Browns Ferry Nuclear Plant, Units 1, 2, and 3
Renewed Facility Operating License Nos. DPR-33, DPR-52, and DPR-68
NRC Docket Nos. 50-259, 50-260, and 50-296

Subject: **Response to NRC Request for Additional Information Related to License Amendment Request for Adding New Specifications to Technical Specification 3.3.8.3 (BFN-TS-486) (CAC Nos. MF6738, MF6739, and MF6740) - Letter 5**

TVA Responses to NRC Request for Additional Information: Set 5

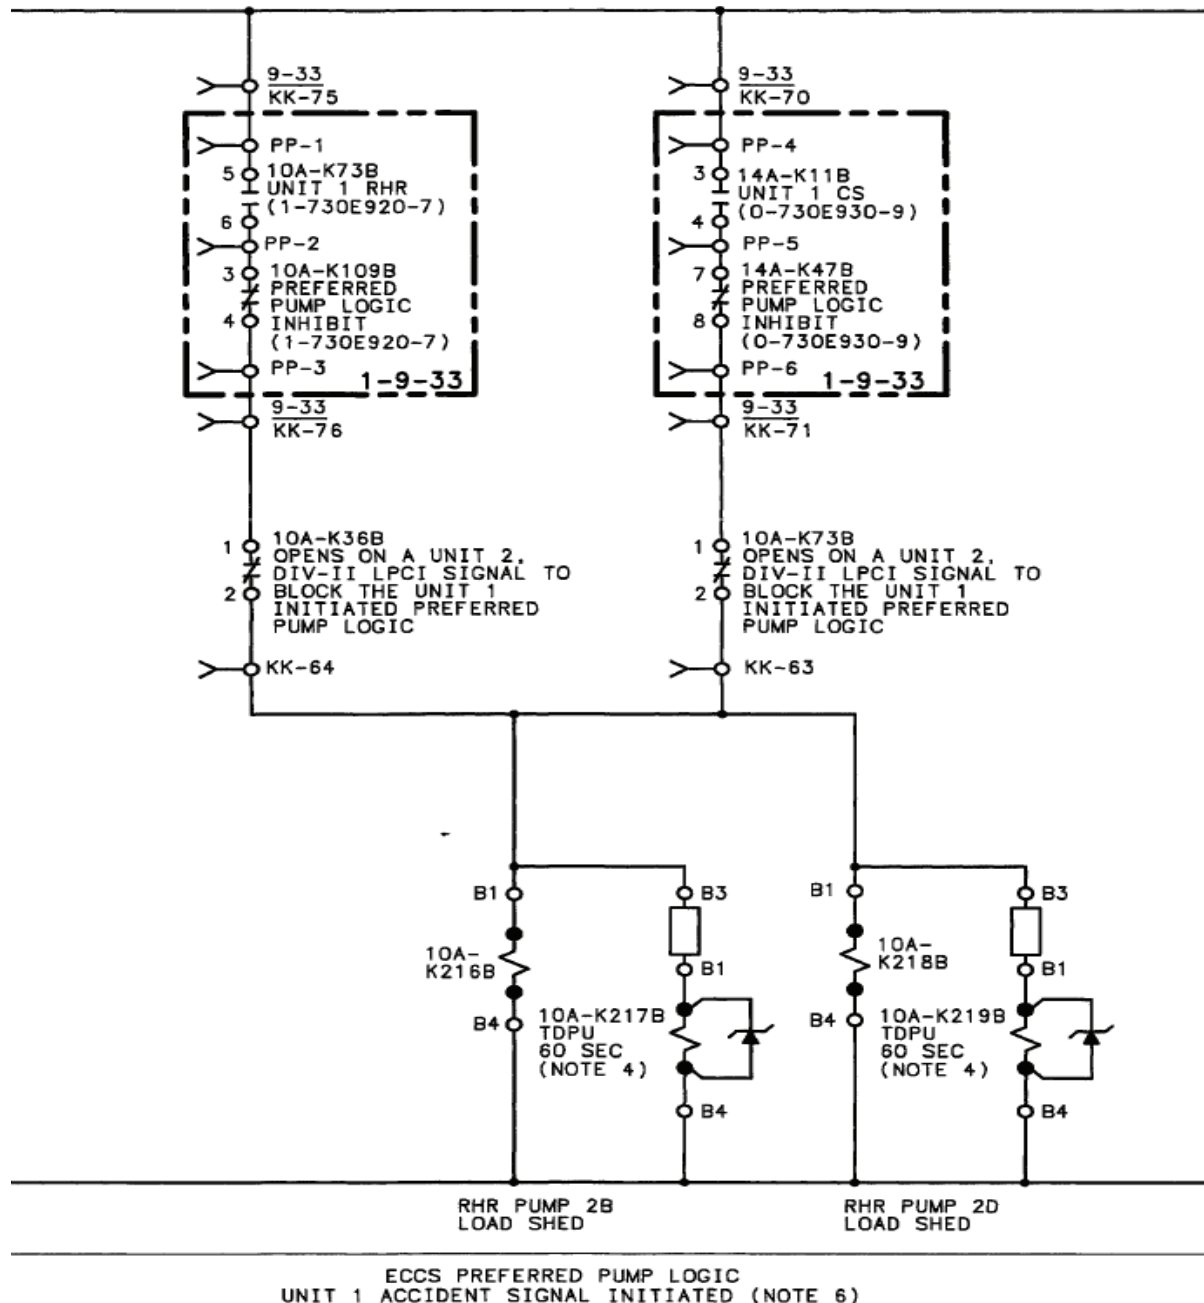
- a. *The LAR states that the fire model considers spurious operation of the ECCS PPL and that adding unavailability of the ECCS PPL to the fire model would decrease CDF/LERF. The LAR does not provide sufficient information for the NRC staff to find this conclusion reasonable. If the fire PRA does not include the PPL unavailability, update the fire PRA to include the PPL unavailability associated with the proposed TS changes, as well as its unreliability, consistent with the American Society of Mechanical Engineers (ASME)/American Nuclear Society (ANS) PRA Standard ASME/ANS RA-Sa-2009, as endorsed by RG 1.200, Revision 2, "An Approach for Determining the Technical Adequacy of Probabilistic Risk Assessment Results for Risk-Informed Activities." In addition, include changes to the internal events PRA, as appropriate, for the fire PRA. Discuss the changes made and include the results for the proposed TS changes as part of APLA-RAI-14.*

In order to demonstrate that the ECCS PPL logic addition is not warranted per ASME/ANS RA-Sa-2009 and that the proposed change in Completion Time from 24 hours to seven days is acceptable, TVA performed a sensitivity analysis that included the ECCS PPL under the SDBD overload gates in the BFN Fire PRA model. This modeling prevents an SDBD overload due to the start of the large ECCS pumps if the ECCS PPL is in service. This is a very conservative approach, given that it ignores any potential fire damage to the ECCS PPL logic and the operator actions to inhibit the ECCS PPL in the event of a fire. For example, under the Unit 1 SDBD A overload gate, the non-credited RHR, RHR Service Water (RHRSW) and CS pumps are prevented from overloading the SDBD by the inclusion of the ECCS PPL logic gates. The ECCS PPL gates contain both unavailability and unreliability Basic Events. The ECCS PPL logic is assumed to be free of fire damage and allowed to function for all fire scenarios evaluated.

Due to the extensive runtimes associated with the BFN Fire PRA, only the BFN Unit 1 CDF was evaluated for this sensitivity analysis. This approach is reasonable, given that past evaluations of the ECCS PPL logic importance showed similar results (i.e., acceptability) between the CDF and LERF of BFN Units 1 and 2. Additionally, the results of the CDF evaluation provided in the table below, demonstrate that with the very conservative modeling used in response to APLA RAI 13.a, the risk effects of the ECCS PPL logic are not significant with respect to fire at BFN.

Delta CDF for ECCS PPL Completion Time		
Unit 1 Base CDF	Unit 1 CDF w/ECCS PPL	Incremental Conditional Core Damage Probability (ICCDP) for Seven Day Completion Time
5.03E-05	3.97E-05	2.03E-07

Based on the sensitivity analysis performed for Unit 1 CDF, TVA concludes that the ECCS PPL does not warrant inclusion into the BFN Fire PRA model. Because the beneficial
